TRANSPORT EQUIPMENT FACTORY

MANDATORY SERVICE MANUAL

No. E/02.142/91

Subject: Extension of aircraft service life
up to 6000 flying hours.

SKETCH No. 2

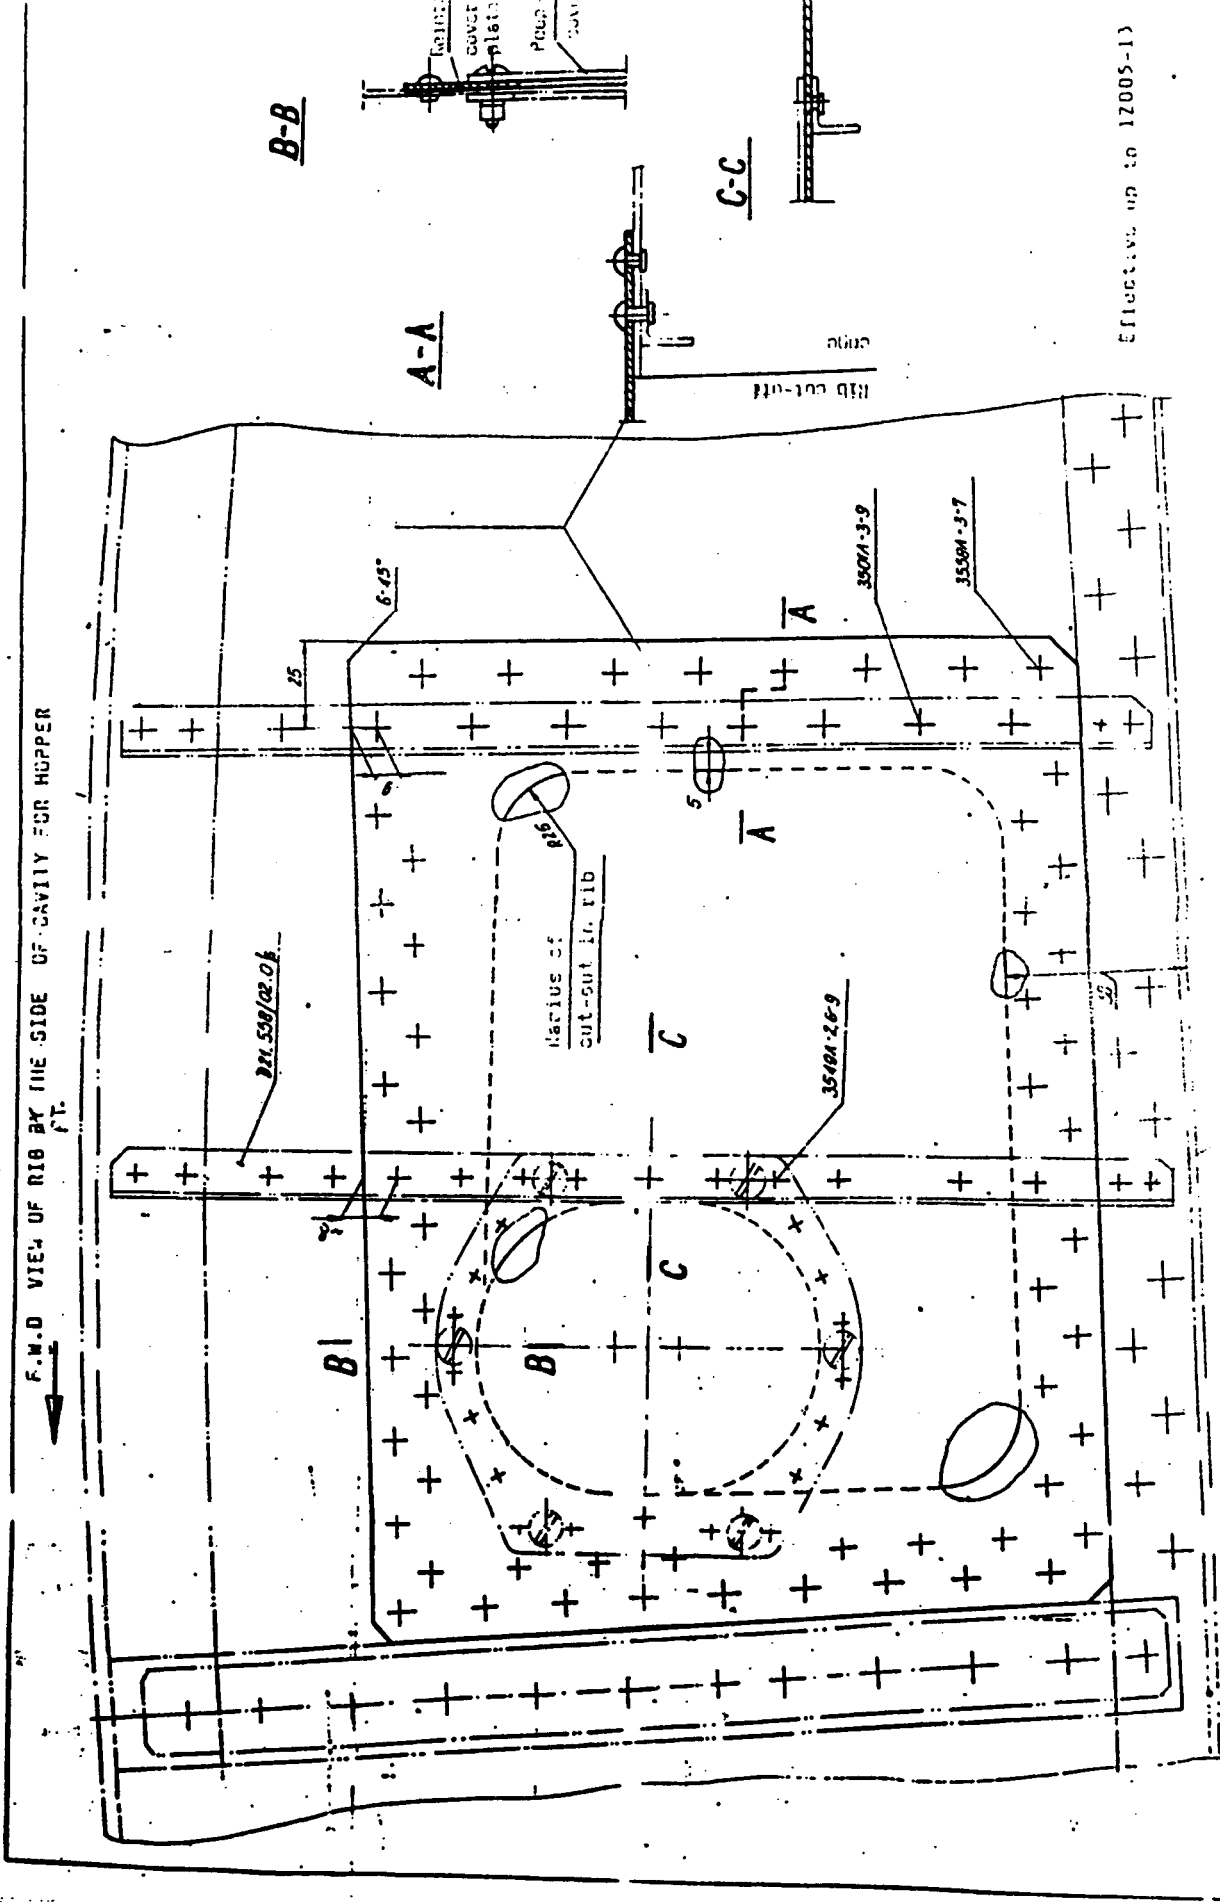
- 3.2.1. To facilitate work at drilling out rivets and boring holes up to dia. 7H8, repair peepholes shall be made in D21.550.00.0L/P ribs per Sketch No.2. To this end, proceed as follows:
- dismantle covers of the existing peep-holes
 - drill out rivets attaching D21.558/02.L/P angle bars and remove them
 - cut out the holes of radius R=25 mm in the ribs.

3.2.9. Rivet the repair cover plate, D21.558/02.0 L/P angle bar and make a peep-hole in the cover plate as shown in Sketch No.2.

SKETCH No. 3

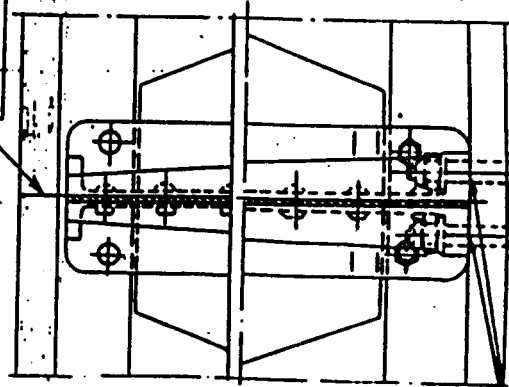
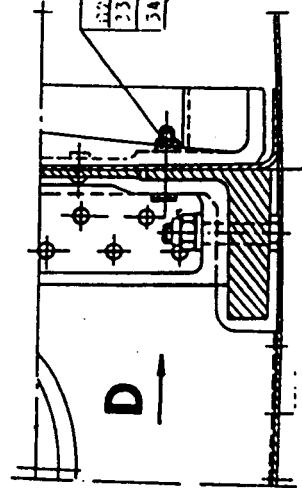
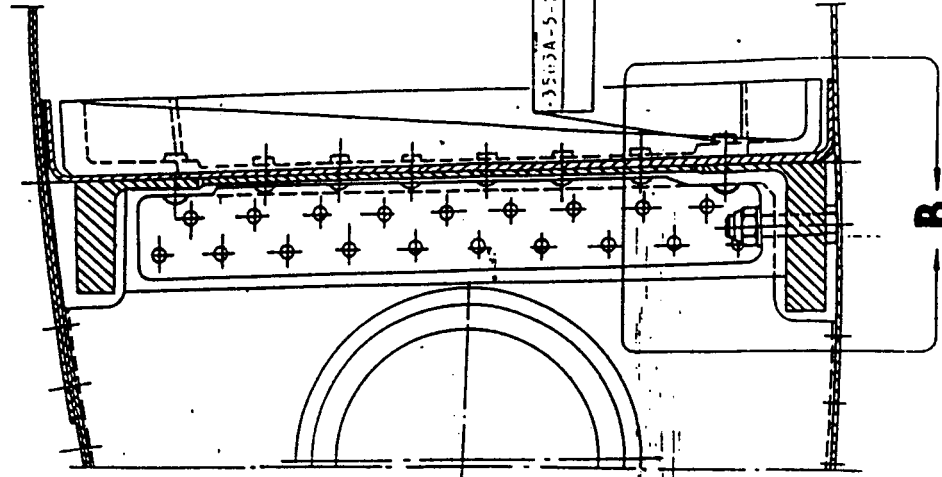
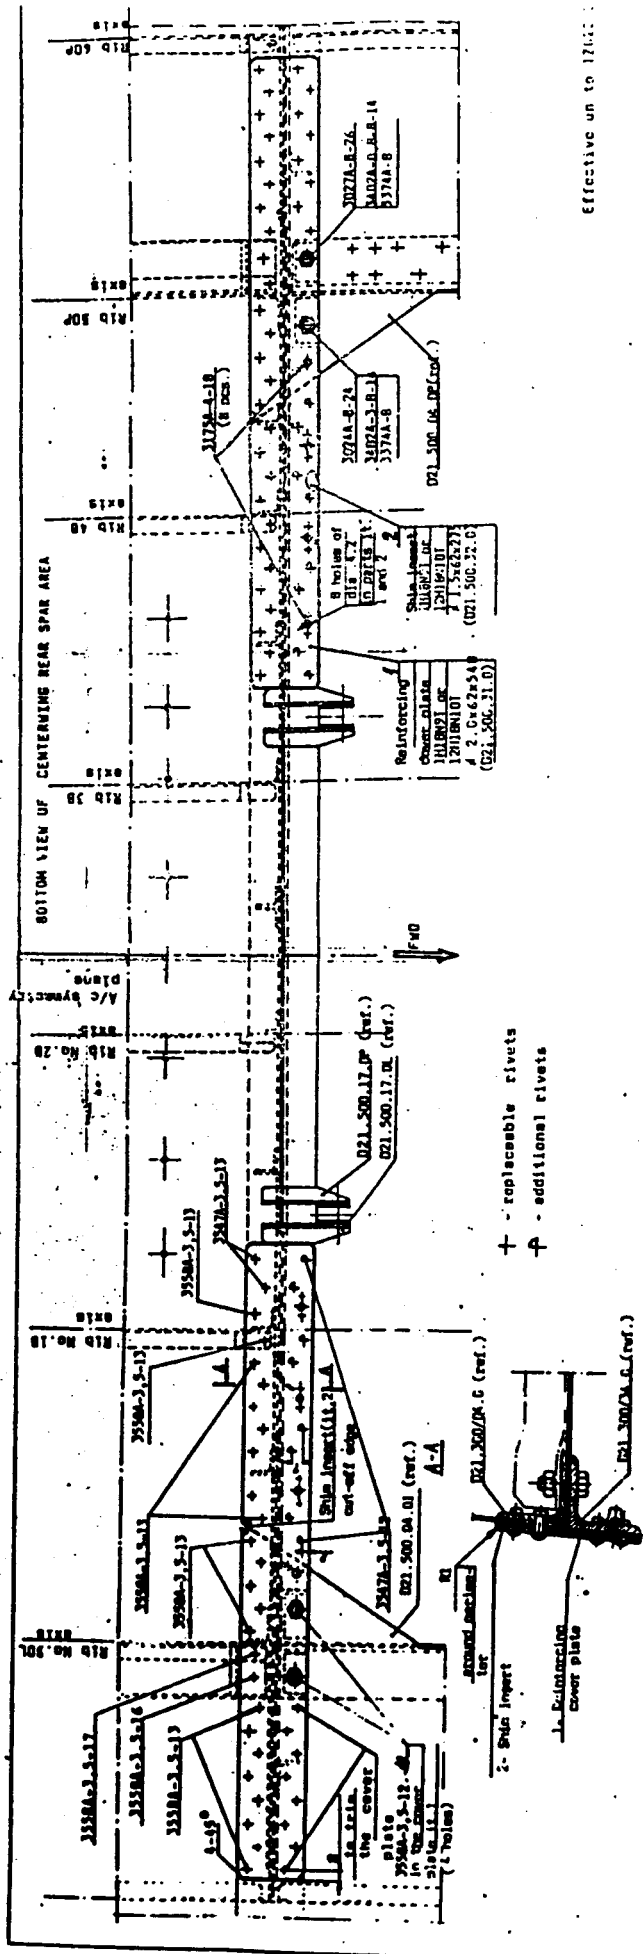
3.2.3. Remove 2 rivets (3503A-5-26) located symmetrically on either side of Rib 5A, view "D", both at the LM and RH aircraft side, in the area shown in Sketch No.3.

3.2.7. Connect the spar flange to the wall with D21.200.01.0R repair bolts as shown in Detail 8, Sketch No.3.

The bracket mount should rest against
spar flange
